PLANNING COMMISSION-CITIZEN ADVISORY COMMITTEE
CITY OF LOWELL, MICHIGAN
AGENDA

FOR THE REGULAR MEETING OF
MONDAY, OCTOBER 12, 2020 AT 7:00 P.M.

To: City of Lowell Planning Commission
Date: September 11, 2020
From: Andy Moore, AICP
Whitney Newberry
RE: 126 S. West Avenue SE

To: City of Lowell Planning Commission
Date: October 9, 2020
From: Andy Moore, AICP
Whitney Newberry
RE: **Grand Rapids Gravel – Special Land Use Application**

1. Building Floor Plan

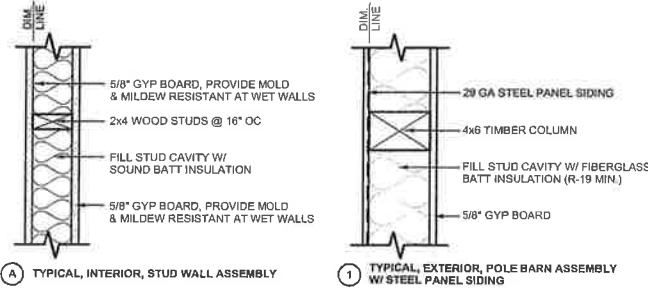
Lighting. The building floor plan includes notes regarding the means of egress illumination. This includes illumination of egress spaces at all times and emergency power in the event of a power supply failure. The locations of exterior building or site lights are not depicted on the site plan. All lighting must comply with Section 4.24, which may be included as a condition of approval.

Parking/Circulation. The applicant is proposing seven parking spaces, including one ADA space. The purpose of this site plan review is to evaluate the building on the site and its potential impacts on the surrounding area. Therefore, a specific land use is not being considered in this application and thus parking requirements are not defined for review. However, because the applicant intends to use the building for retail and warehouse purposes, parking requirements for these uses are considered to ensure the building would be appropriately situated to accommodate parking for future occupancy.

Retail stores require one parking space for each 200 square feet of gross floor area. The site plan indicates that the mercantile portion of the building is 855 square feet, equating to five required spaces. Warehouse uses require one parking space for each 2,000 square feet of gross floor area, with a minimum of four spaces. The site plan notes that the building's storage use is approximately 1,545 square feet, requiring a minimum of four spaces. In total, nine spaces would be required for this building if it is later approved for warehouse and retail uses. Therefore, it is worth noting that additional parking may be required in the future to satisfy future parking requirements.

FOUNDATION PLAN
SCALE: 1/4" = 1'-0"

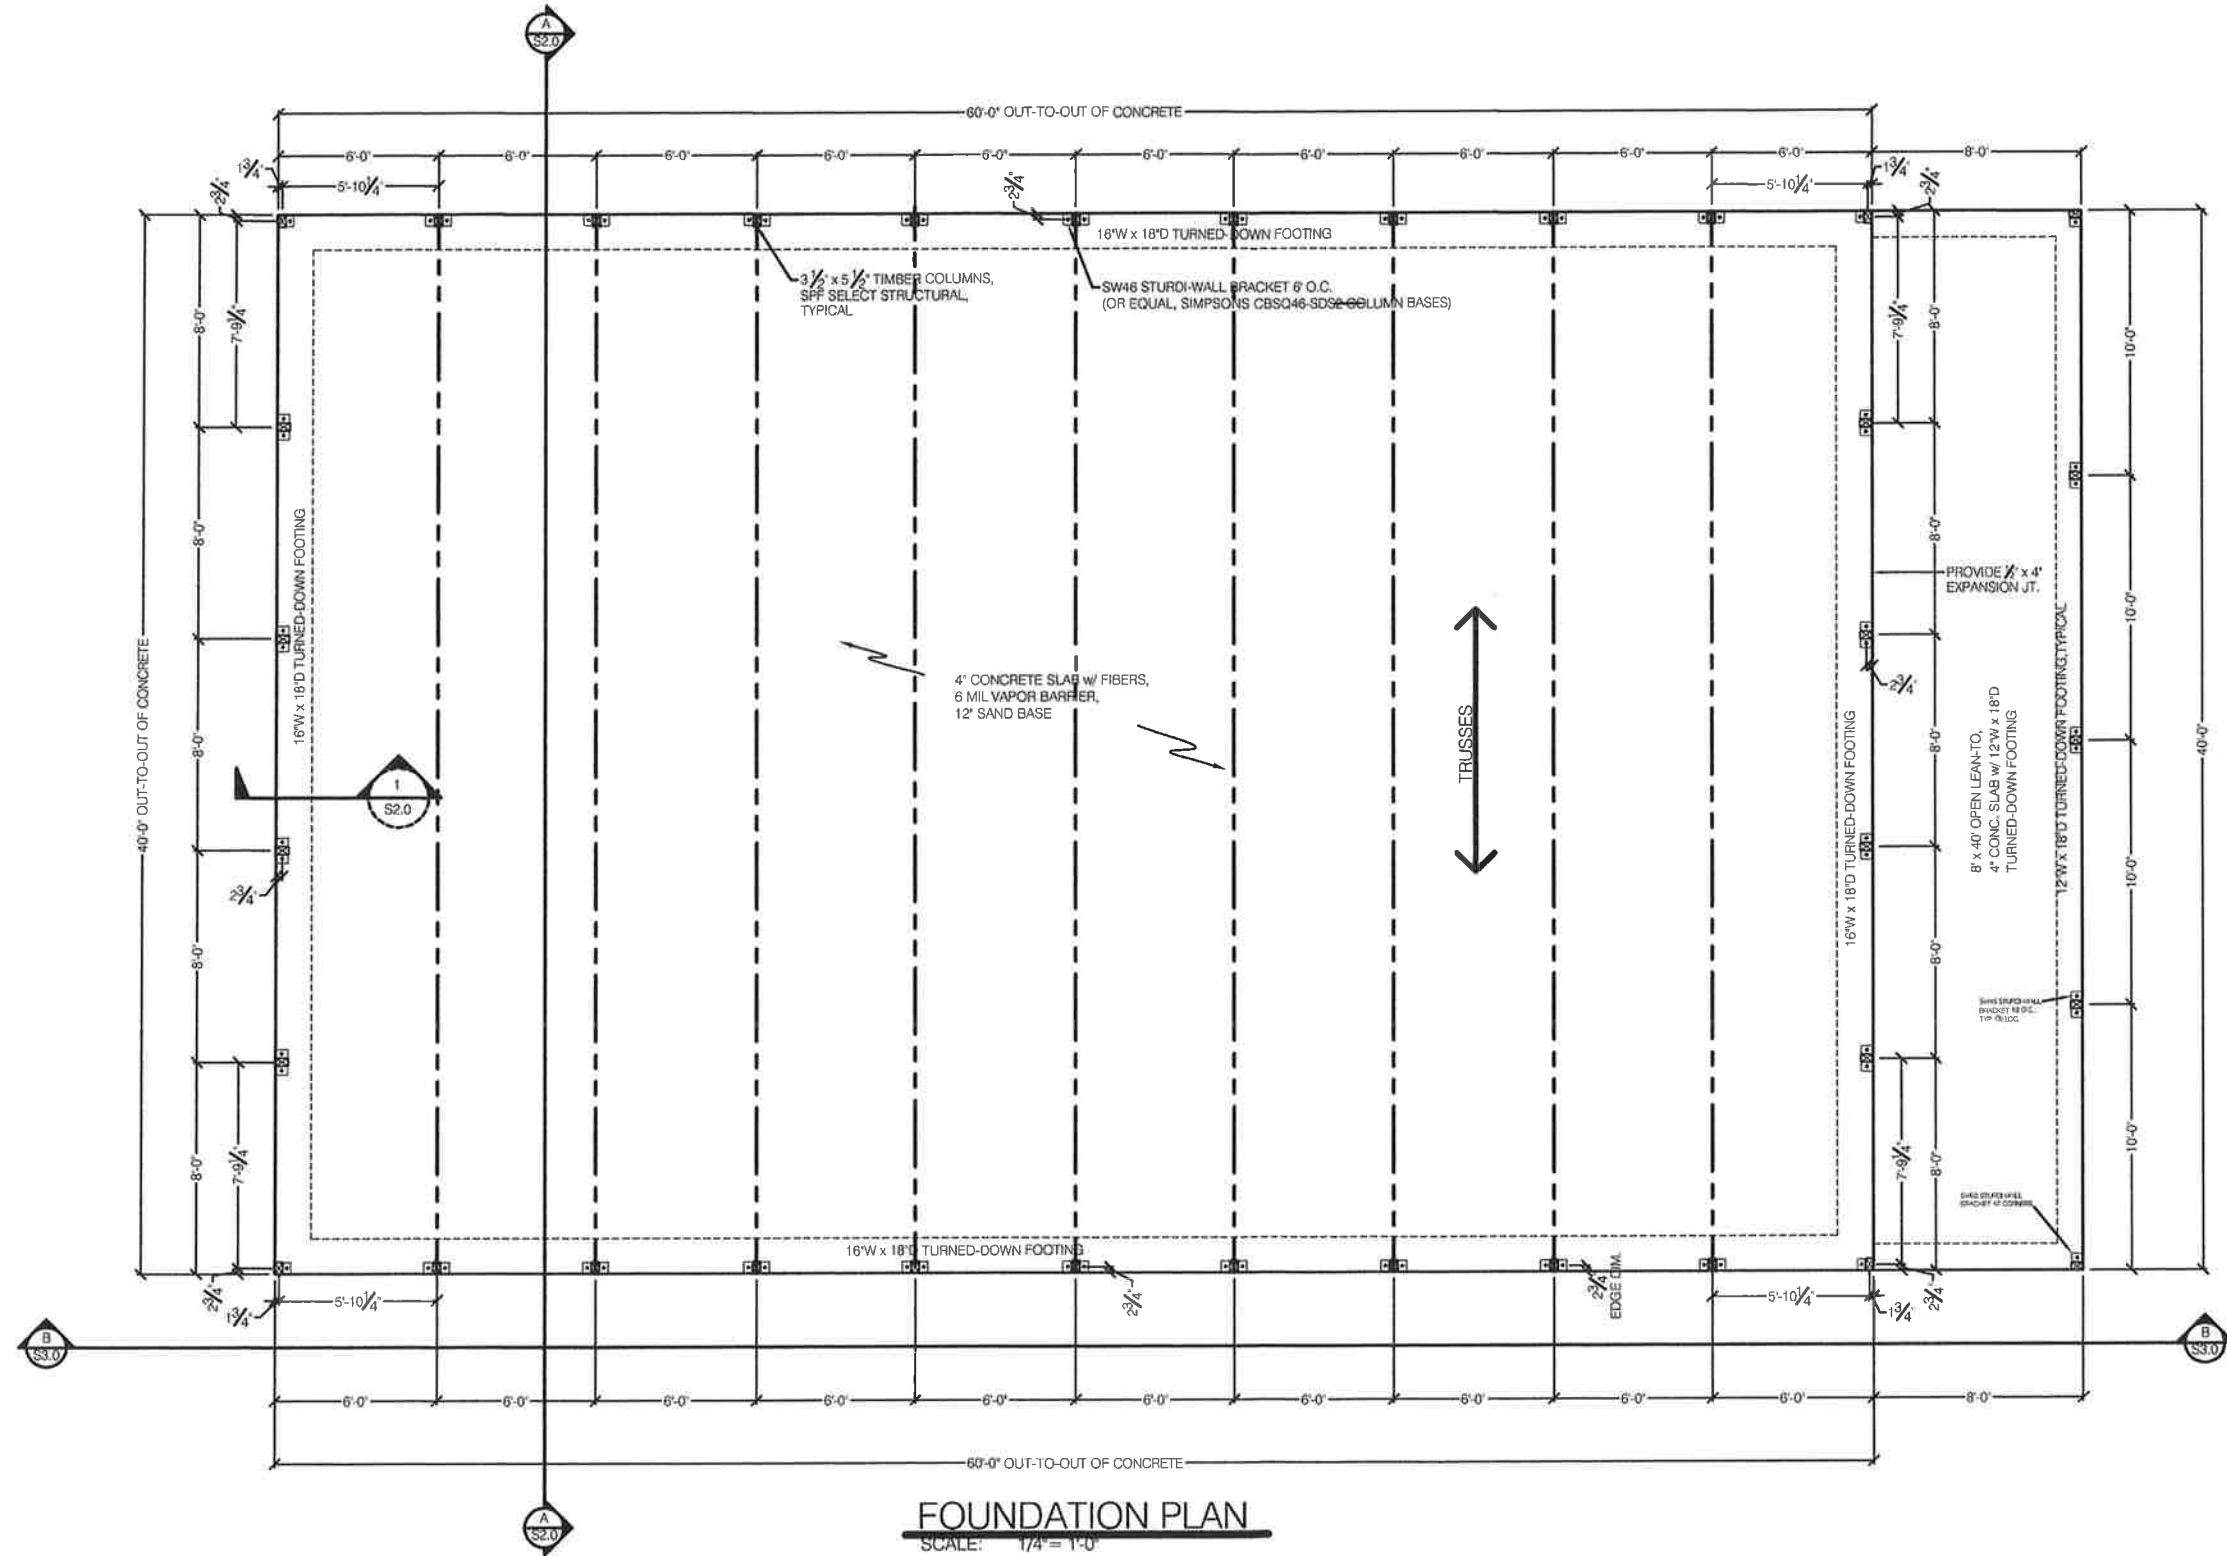
Setbacks and Dimensional Requirements. The site plan appears to meet the front, side, and rear setback requirements. The subject property is legally nonconforming in terms of its lot area and width. Section 12.04 requires a minimum lot size of 20,000 square feet and a lot width of 100 feet in the C3 district. The subject property is about 13,000 square feet and has a width of 66 feet. However, the City permits nonconforming lots to be developed in accordance with the underlying zoning district, provided that all applicable setbacks are met.
